UPS SAV TENANT IMPROVEMENT

UNITED PARCEL SERVICE INC.

Stratus Project No.2025-1073

ADDENDUM 1 - 03/18/2026

1 ENLARGED RESTROOM PLAN
A-403 1/2" = 1'-0"

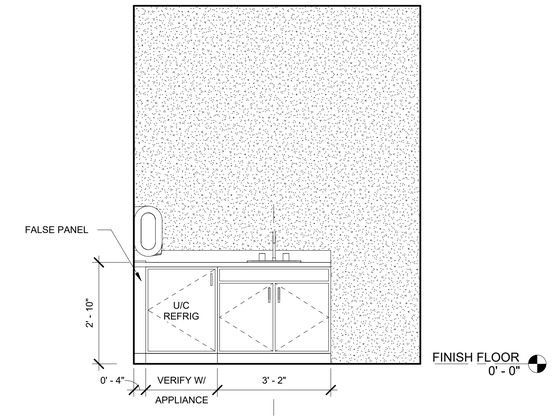
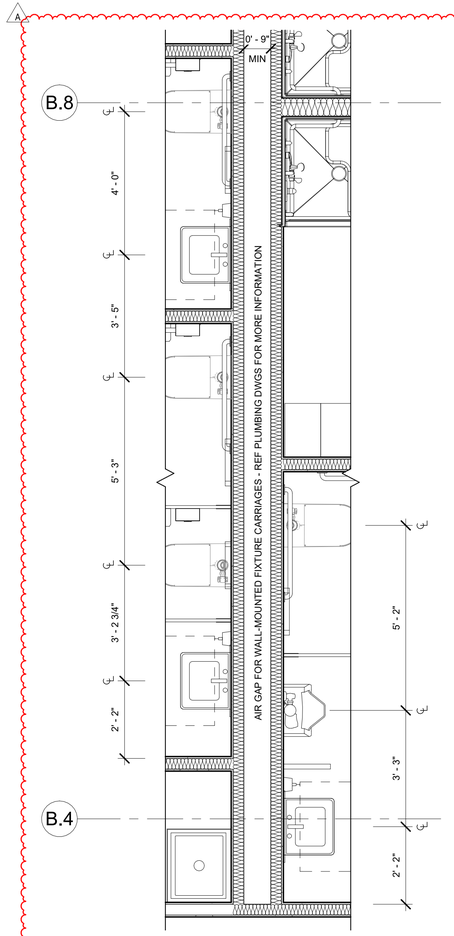
G-001	REMOVED DRAWING INDEX AND ADDED IT TO SHEET G-002
G-002	REVISED SHEET.
G-003	UPDATED PROJECT ADDRESS.
G-003	REVISED SHEET NUMBER.
G-004	UPDATED PROJECT ADDRESS.
G-004	REVISED SHEET NUMBER.
G-005	UPDATED PROJECT ADDRESS.
G-005	REVISED SHEET NUMBER.
G-006	UPDATED PROJECT ADDRESS.
G-006	REVISED SHEET NUMBER.
G-101	RELOCATED EYE WASH STATION TO EXTERIOR WALL.
G-101	UPDATED PROJECT ADDRESS.
AD-101	UPDATED PROJECT ADDRESS.
A-101	RELOCATED EYE WASH STATION TO EXTERIOR WALL.
A-101	ADDED SHEET NOTES 4 AND 5.
A-101	UPDATED PROJECT ADDRESS.
A-301	UPDATED PROJECT ADDRESS.
A-401	UPDATED PROJECT ADDRESS.
A-401	REVISED DIMENSION VALUE / SHIFTED WALL LOCATION.
A-402	UPDATED PROJECT ADDRESS.
A-403	UPDATED PROJECT ADDRESS.
A-403	REVISED DIMENSION VALUE / SHIFTED WALL LOCATION.
A-403	REVISED DIMENSION VALUE / SHIFTED WALL LOCATION.
A-403	REVISED DIMENSION VALUE / SHIFTED WALL LOCATION.
A-403	ADDED ENLARGED PLAN AND FIXTURE SCHEDULE.

ENLARGED RESTROOM REFLECTED CEILING PLAN

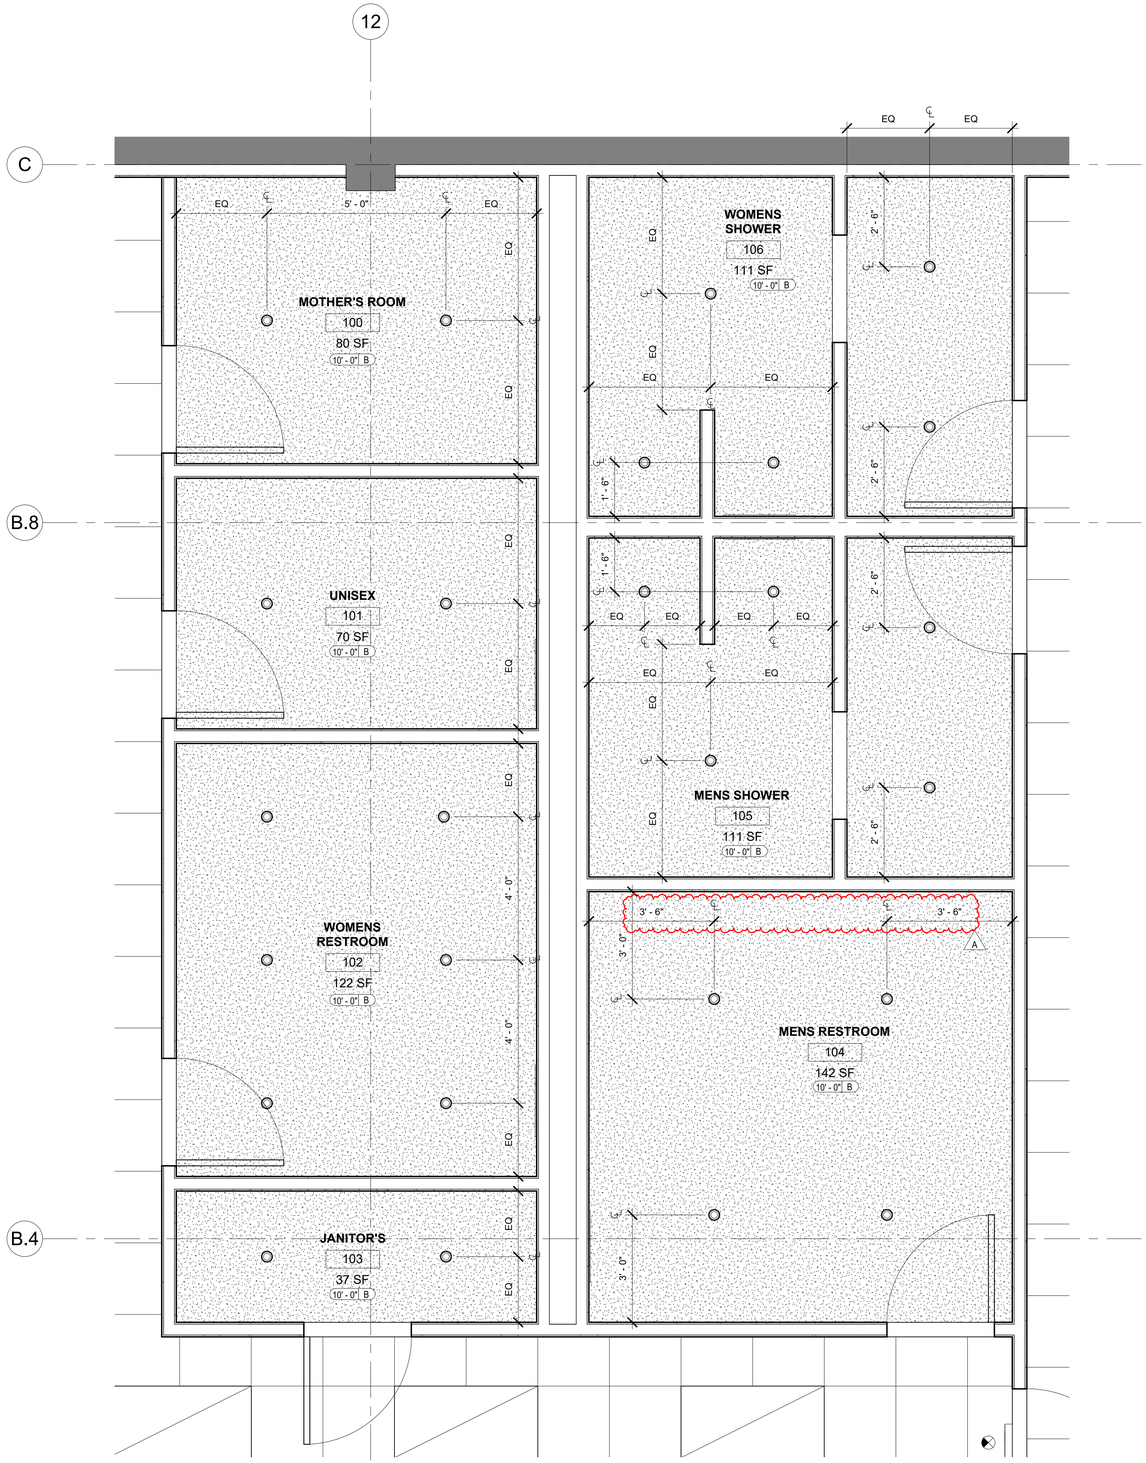
A-404	UPDATED PROJECT ADDRESS.
A-404	REVISED DIMENSION FOR LIGHT LOCATIONS IN MENS RESTROOM (ROOM #104).
A-600	UPDATED PROJECT ADDRESS.
A-600	REVISED DOOR TYPE FOR DOORS 108A, 108B, 109, 110B, 113, 114, AND 115 IN DOOR SCHEDULE.
A-600	REVISED DOOR TYPE C AND ADDED DOOR TYPE CC TO DOOR TYPE LEGEND.
A-701	UPDATED PROJECT ADDRESS.
A-701	REVISED FLOOR FINISH FROM CARPET TO SEALED CONCRETE IN TRAINING ROOM (ROOM #113).
A-701	REMOVED CARPET FROM FINISH SCHEDULE.
A-702	UPDATED PROJECT ADDRESS.
A-702	REMOVED CARPET FROM FINISH SCHEDULE.
FP-101	UPDATED PROJECT ADDRESS.
P-001	UPDATED PROJECT ADDRESS.
P-002	UPDATED PROJECT ADDRESS.
P-101	UPDATED PROJECT ADDRESS.
P-101	RELOCATED EYE WASH STATION TO EXTERIOR WALL.
P-102	UPDATED PROJECT ADDRESS.
P-102	RELOCATED EYE WASH STATION TO EXTERIOR WALL.
P-103	UPDATED PROJECT ADDRESS.
P-103	REVISED WASTE, VENT, AND SUPPLY LINES TO PLUMBING FIXTURES IN WOMENS SHOWER, MENS SHOWER, AND MENS RESTROOM.

6 BUILDING 1 DOMESTIC RISER PLAN

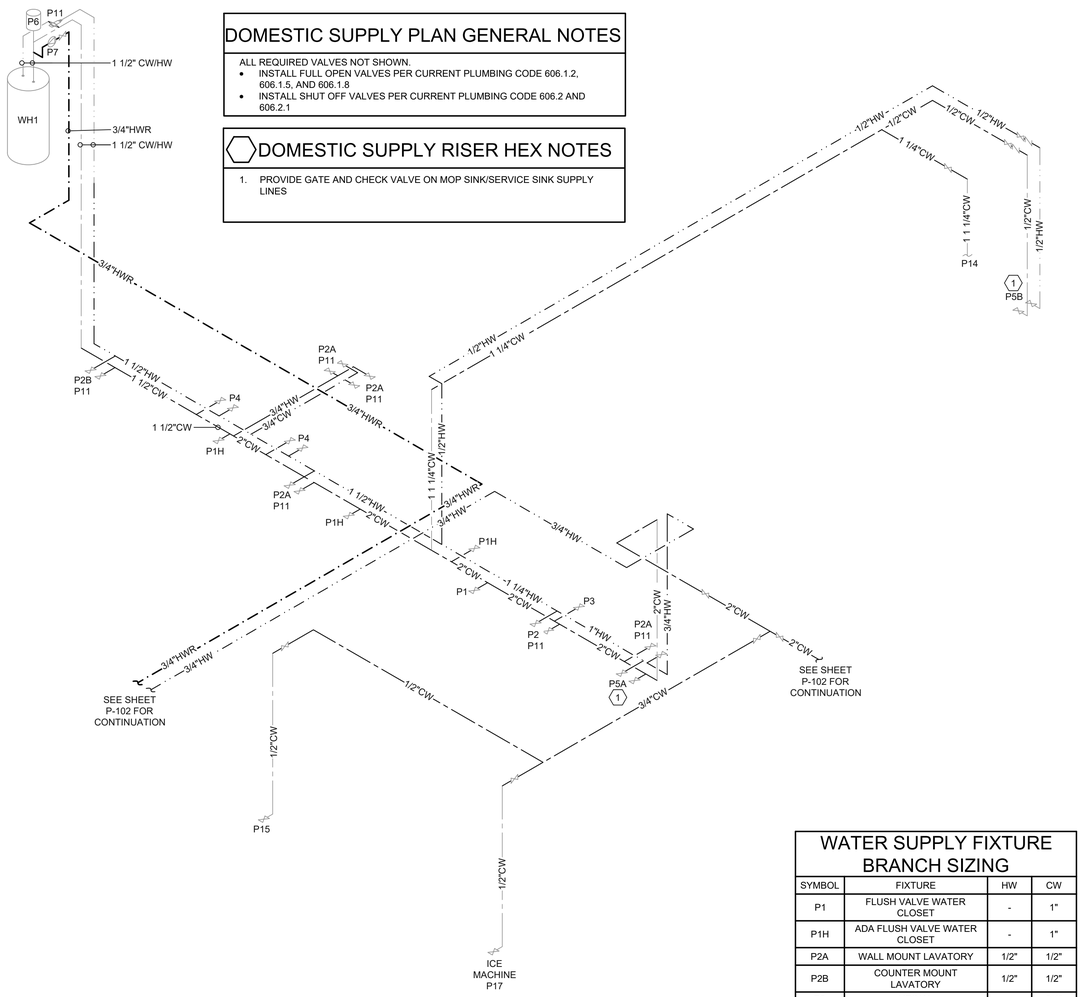
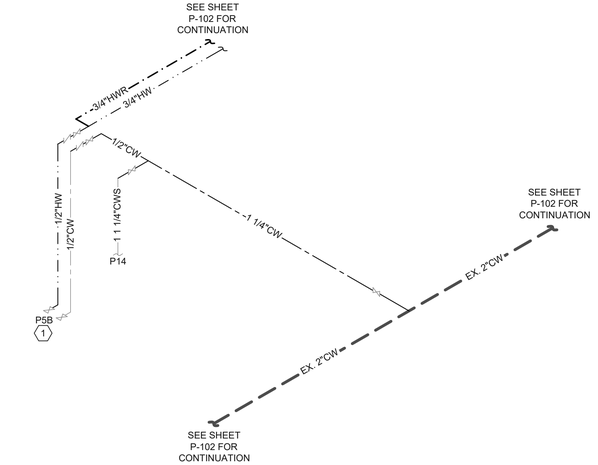
P-201	UPDATED PROJECT ADDRESS.
P-201	REVISED RISER DIAGRAM 3 AND 6.
M-001	UPDATED PROJECT ADDRESS.
M-101	UPDATED PROJECT ADDRESS.
M-102	UPDATED PROJECT ADDRESS.
M-102	REVISED MEHCANICAL LAYOUT IN WOMENS SHOWER, MENS SHOWER, AND MENS RESTROOM.
M-103	UPDATED PROJECT ADDRESS.
M-103	REVISED MEHCANICAL LAYOUT IN WOMENS SHOWER, MENS SHOWER, AND MENS RESTROOM.
M-201	UPDATED PROJECT ADDRESS.
M-301	UPDATED PROJECT ADDRESS.
E-001	UPDATED PROJECT ADDRESS.
E-101	UPDATED PROJECT ADDRESS.
E-102	UPDATED PROJECT ADDRESS.
E-102	REVISED ELECTRICAL LAYOUT IN WOMENS SHOWER, MENS SHOWER, AND MENS RESTROOM.
E-103	UPDATED PROJECT ADDRESS.
E-104	UPDATED PROJECT ADDRESS.
E-104	REVISED ELECTRICAL LAYOUT IN WOMENS SHOWER, MENS SHOWER, AND MENS RESTROOM.
E-105	UPDATED PROJECT ADDRESS.
E-105	REVISED BACKGROUND FOR WOMENS SHOWER, MENS SHOWER, AND MENS RESTROOM.
E-105	REVISED CAMERA AND ACCESS GENERAL NOTES.
E-201	UPDATED PROJECT ADDRESS.
